## REMARKS

Applicant hereby acknowledges the Examiner's finding of allowability with respect to claims 2-4, 6-9, and 12 in the July 14, 2003 Office Action.

In the July 14, 2003 Office Action, the Examiner objected to Figure 3 for contradicting Figure 2, on the basis that Figure 2 shows a hanging diaphragm element 13 and a standing diaphragm element 14, while Figure 3 shows the diaphragm element 13 as standing and 14 as hanging instead.

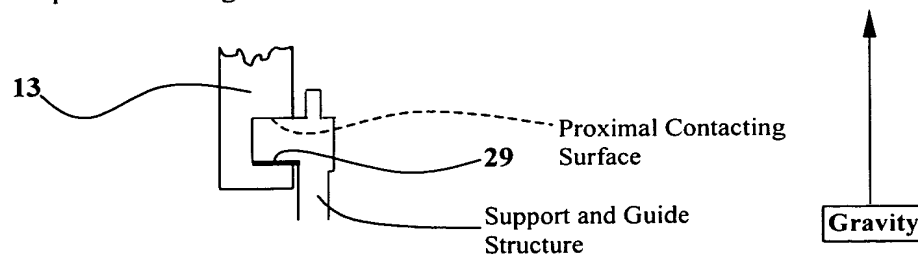
For the diaphragm element 13, Figure 3 shows the following relationship between the diaphragm element 13 and its respective bearing surface 29:

If the diaphragm element 13 of Figure 3 were in fact standing upon the support and guide structure, the bearing surface 29 that supports the weight of element 13 would be the proximal contacting surface (as indicated by the dotted line), instead of the distal contacting surface as shown in Figure 3. From the fact that the distal contacting surface between the diaphragm element 13 and the support and guide structure functions as the bearing surface that supports the weight of element 13, it is evident that gravity actually points upward in Figure 3, and that Figure 3 shows an upside-down drawing in which the diaphragm element 13 is actually hanging on the support and guide structure at the bearing surface 29 that is distal to such diaphragm element 13. Therefore, the diaphragm element 13 of Figure 3 is a hanging diaphragm, not a standing diaphragm.

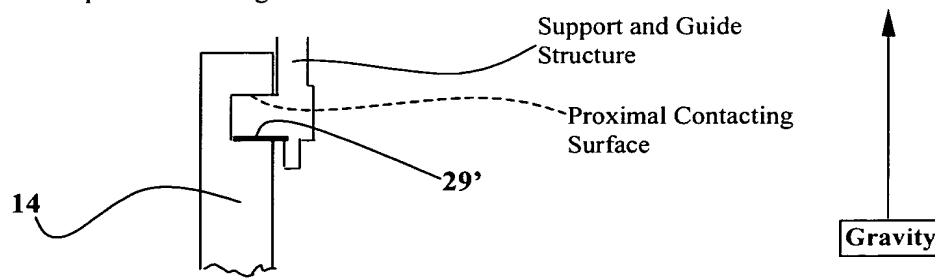
For diaphragm element 14, Figure 3 shows the following relationship between the diaphragm element 14 and its respective bearing surface 29':

If the diaphragm element 14 of Figure 3 were in fact hanging over the support and guide structure, the bearing surface 29' that supports the weight of element 14 would be the distal contacting surface (as indicated by the dotted line), instead of the proximal contacting surface as shown in Figure 3. From the fact that the proximal contacting surface between the diaphragm element 14 and the support and guide structure functions as the bearing surface that supports the weight of element 14, it is evident that gravity actually points upward in Figure 3, and that Figure 3 shows an upside-down drawing in which the diaphragm element 14 is actually standing on the support and guide structure at the bearing surface 29' that is proximal to such diaphragm element 14. Therefore, the diaphragm element 14 of Figure 3 is a standing diaphragm, not a hanging diaphragm.

Therefore, Figure 3 does not contradict Figure 2, and both Figures 2 and 3 show a hanging diaphragm element 13 and a standing diaphragm element 14.

Applicant hereby apologizes for any confusion caused by the upside-down configuration of Figure 3, and respectfully requests the Examiner to review, and upon review to withdraw, the objection of Figure 3.

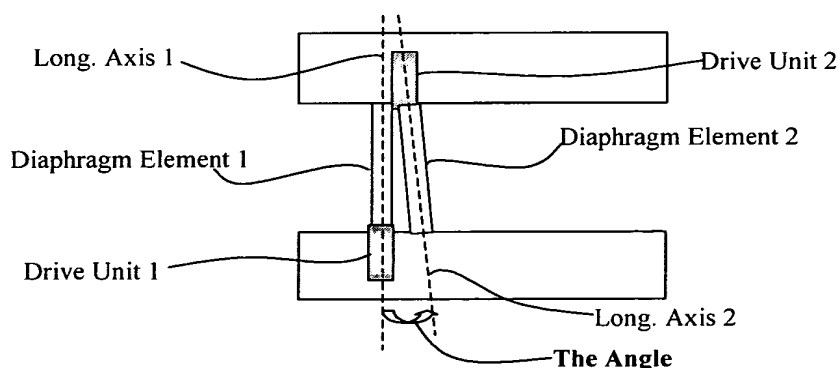
In response to the Examiner's objection to the drawings in Section 4 of the Office Action based on failure to show the angle recited in claim 6, Applicant has amended the instant specification on page 4, by correcting certain mistranslation of the specification from the original German text into English. Specifically, the German phrase "in ihrer Erstreckung" should be translated as "in their extent" instead of "over the distance." Corresponding corrections have been made to claim 6, by defining the longitudinal axes of the two diaphragm elements as "extend[ing] from the respective drive units to the respective sides opposite to said drive units," instead of "over the distance from the drive unit to their facing side," which is a cumbersome locution.

By correcting the mistranslations, the meaning of claim 6 becomes clear, which specifies an angle formed between the longitudinal axes of the two diaphragm elements that extend from the respective drive units to the respective opposite sides, as follows:

An ordinary person, by reading claim 6, will readily understand the claimed subject matter with respect to such angle formed by the longitudinal axes of at least two diaphragm elements. Therefore, a specific drawing showing such angle is not necessary for understanding the subject matter claimed by claim 6, and therefore is not required by 37 C.F.R. §1.83(a).

Figure 2 (Front View)

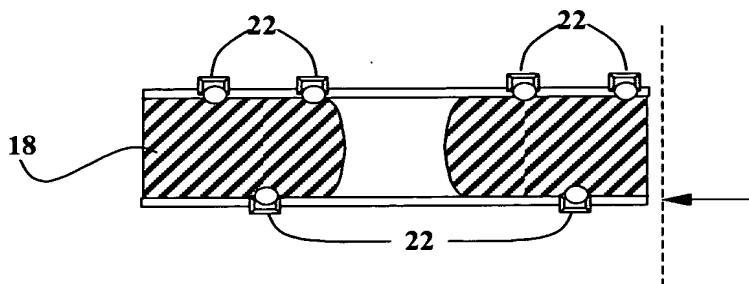
Specifically, the Span reference discloses that each leaf 18 (i.e., diaphragm element) is supported at both an upper edge and a lower edge by an arrangement of three (3) grooved rollers 22, while two of the grooved rollers 22 are spaced along the upper edge of the leaf 18, and one of the groove rollers 22 is placed intermediately in contact with the lower edge of the leaf 18, "so that the leaf is firmly located in a linearly displaceable manner for all variations in the attitude of the head 7" (See Span, Figure 2, and column 4, lines 21-27).

The relationship between the view showed by Figure 2 and Figure 5 of Span are as follows:

Figure 5 (Lower Side View)

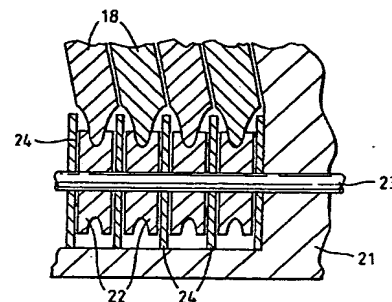
Figure 5 of Span shows an enlarged view of the bearing supports relating to the grooved rollers 22 at the lower edges of the leaves 18, wherein the weight of the leaves 18 falls upon the grooved rollers 22 and is further carried by the disc washers 24 displaced between the grooved rollers 22, as described at column 4, lines 32-44 of the Span reference.

Figure 5 only shows the grooved rollers 22 and disc washers 24 supporting the leaves 18 at the lower edges, but it does not mean that the leaves 18 are supported only at the lower edges. Instead, the leaves 18 of Span are also supported by grooved rollers 22 and disc washers 24 at the upper edges, as shown by Figure 2 and disclosed by column 4, lines 21-27 of the Span reference.

Therefore, Span actually discloses diaphragm elements that are supported at both a first terminal portion (i.e., one of the upper or lower edges) and a second terminal portion that is opposite to such first terminal portion (i.e., the other of the upper or lower edges), and it does not provide any derivative basis for a diaphragm element that is supported on only a first terminal portion near the drive unit, as required by independent claim 1 (from which claims 5, 11, and 10 depend) of the present application.

Fig. 5

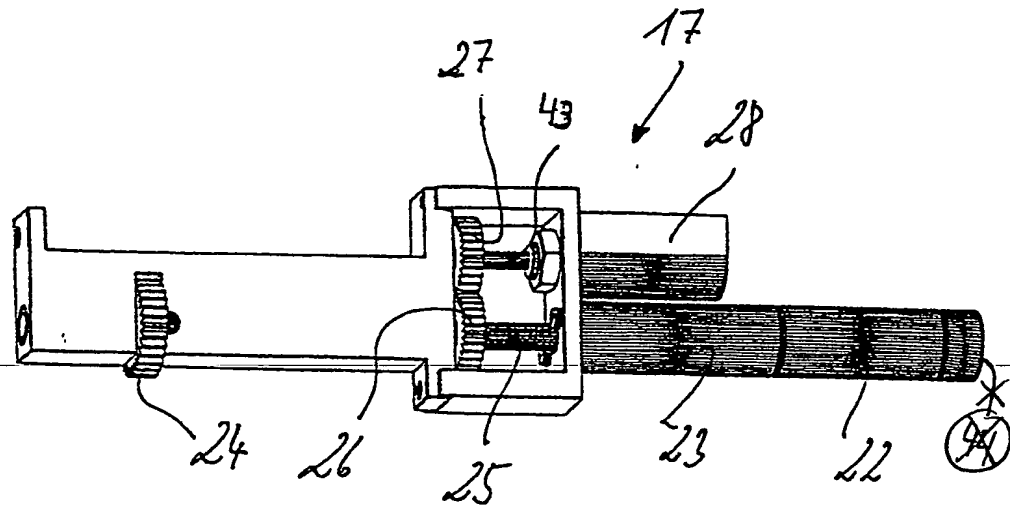
The drawing objections raised by the Examiner in Sections 2 and 3 of the Office Action have been overcome hereby via amendments to Figure 5 and to the instant specification on pages 9-11. Specifically, Figure 5 has been amended by deleting the reference numeral 44 that is not mentioned in the specification. The instant specification has been amended on page 10, line 2 by change the reference numeral for the shaft from 40 to 43. Further, the instant specification has been amended on page 11, by changing the reference number 63 at line 6 into "64," and by adding reference number 66 behind the phrase "at one end" at line 7, consistent with the drawing in Figure 9.

Fig 8

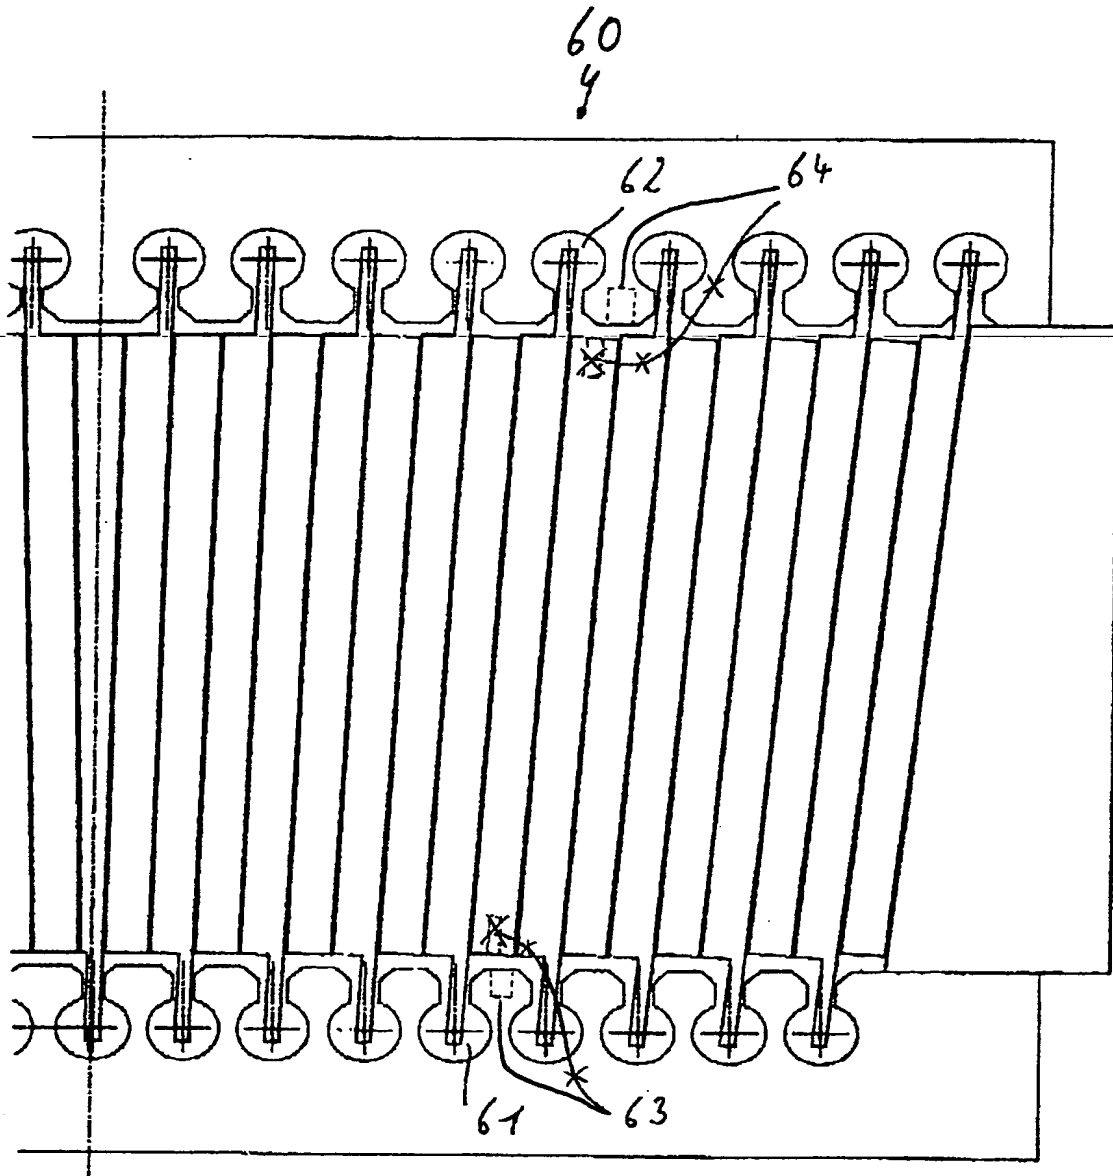
A new set of formal drawings for Figures 1-9 and associated marked-up copies showing changes made to Figures 5 and 8 are attached herewith for the Examiner's review and approval in **Appendixes B and C**. Applicant hereby requests the Examiner, upon approval of the changes made thereby, to forward the new formal drawings to the Official Draftsperson's Office. Such new formal drawings overcome all the objections raised by the Official Draftsperson in the June 27, 2003 Notice of Draftsperson's Patent Drawing Review enclosed in the July 14, 2003 Office Action.
